# 140 MW SOLAR PHOTOVOLTAIC PROJECT IN RAJASTHAN

| <b>Report ID</b>     | VKU.VER.69.22_VCS_1709                         |

| <b>Report Title</b>        | 140 MW Solar Photovoltaic Project in Rajasthan   |
| <b>Date of Issue</b>       | 28-March-2023  |

**Figure 02: Trends of PLF from March 2021 to September 2021**

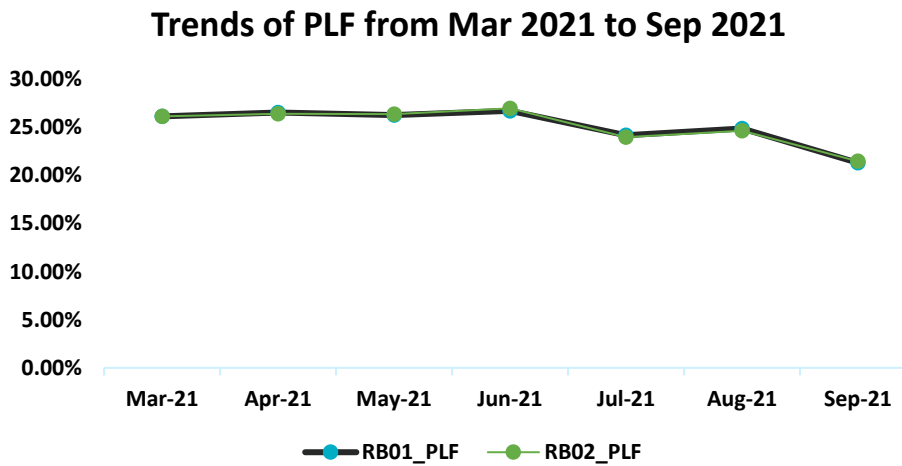
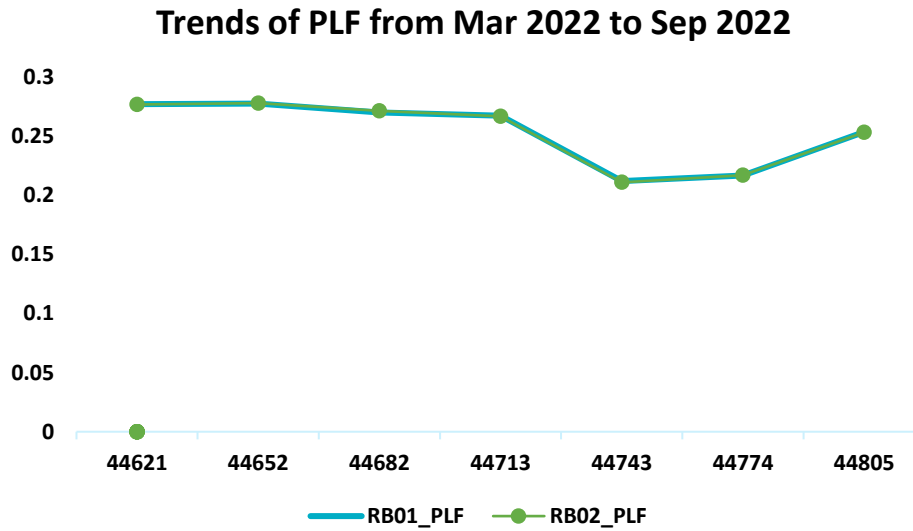
Upon comparing Figure 02 and 03, it is clear that the trend of PLF in 2022 has been higher than the comparable period in 2021. This is reflected in higher emission reductions for the current monitoring period at 20.70%. At the same time upon checking the IRR sheet to check the additionality, it was found that although the achieved PLF is higher than the estimate, it is within the sensitivity bound. In other words, PLF has to touch or breach 25.55% to cross the IRR, while the achieved PLF for the monitoring period is 24.62%. Hence assessment team accepted higher emission reductions due to vagaries in sunshine pattern which is beyond the control of the PP.

This comparison is submitted in the ER sheet along with a justification confirming that this event of higher power generation was an unforeseen situation and also not under the direct control of PP.
